San Francisco Public Utilities Commission
Peninsula Pipelines Seismic Upgrade Project
San Mateo County, California

**Responses to Comments on
Draft Environmental Impact Report**

Re: **Attached Responses to Comments on Draft Environmental Impact Report Case No. 2011.0123E, Peninsula Pipelines Seismic Upgrade Project**

FIGURE RTC 4-1 (REVISED FIGURE 3-2)

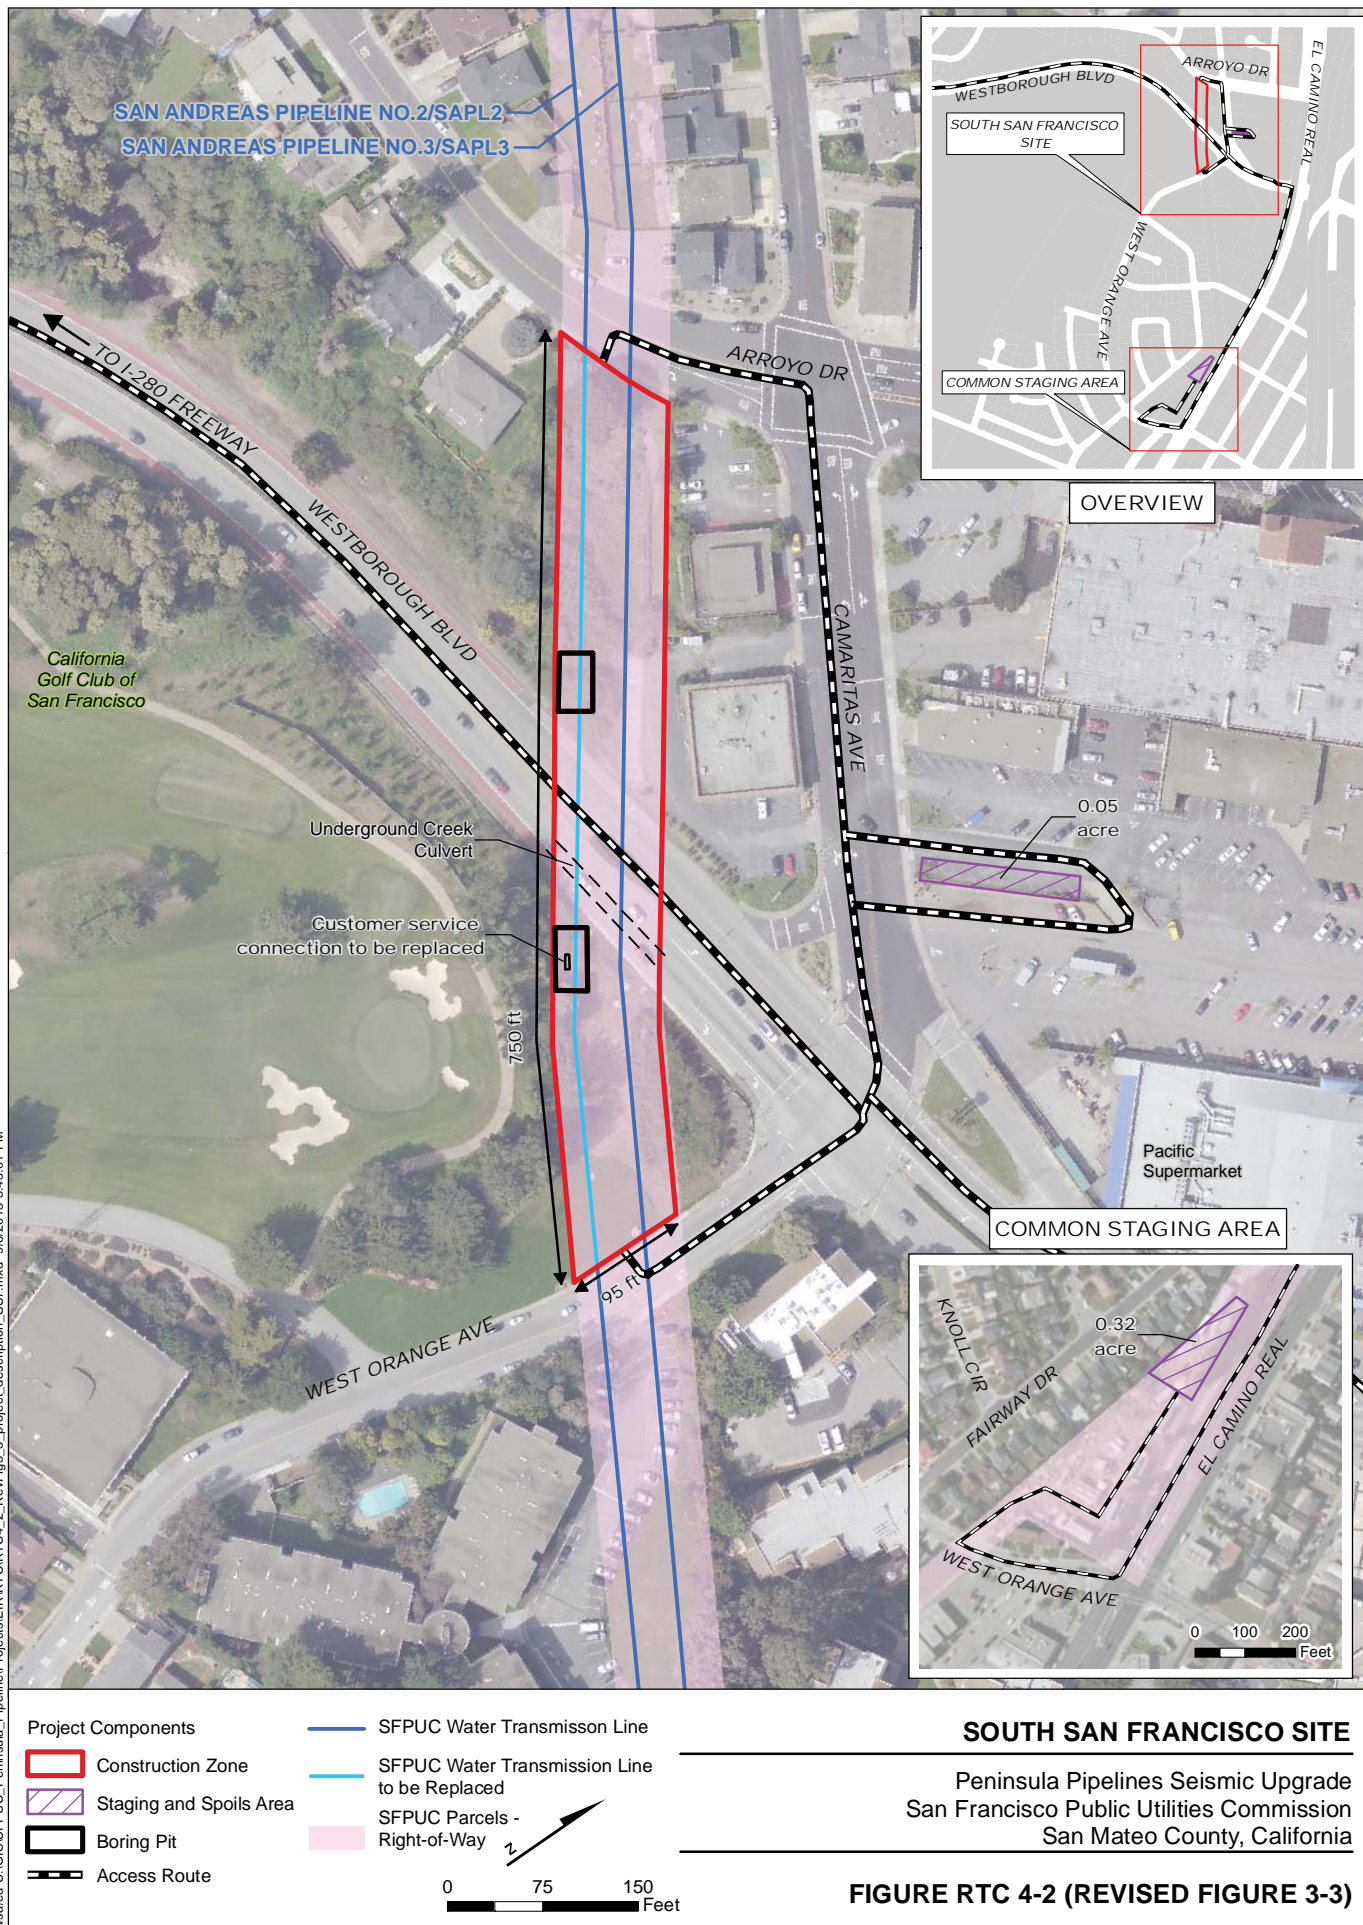
Figures 3-2 and 3-3 of the Draft EIR show wholesale customer service connections to be replaced at the Colma and South San Francisco sites; these figures have been updated to more accurately show the scale of the turnout replacement dimensions. Figure 3-5 has been revised to show the customer service connection to be replaced. Similarly, Figures 3-7 and 3-9 through 3-10 have been revised to show the customer service connections to be replaced (plan and profile views). The revised figures are provided in this document in Section 4.2, Figure Revisions.

- Figure 3-2, Colma Site, on page 3-4, in Section 3.1, Project Location, has been revised to more accurately show the scale of the wholesale customer service turnout replacement dimensions, as shown in Figure RTC 4-1.
